MSC200 Series Flow Control Valve Profile and Order

Code Change Notification

MSC200-6A, MSC200-8A

3. Change descriptions

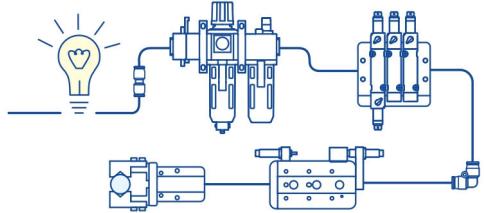
According to market feedback, add mounting holes on the side of the product.

Discontinued	Alternatives
	MSC200 Series	MSC201 Series
Dimension	6A : 8A : 	6A : 8A :

MSC201 series will be available from now on.

MSC200 series will be discontinued after June, 2022.
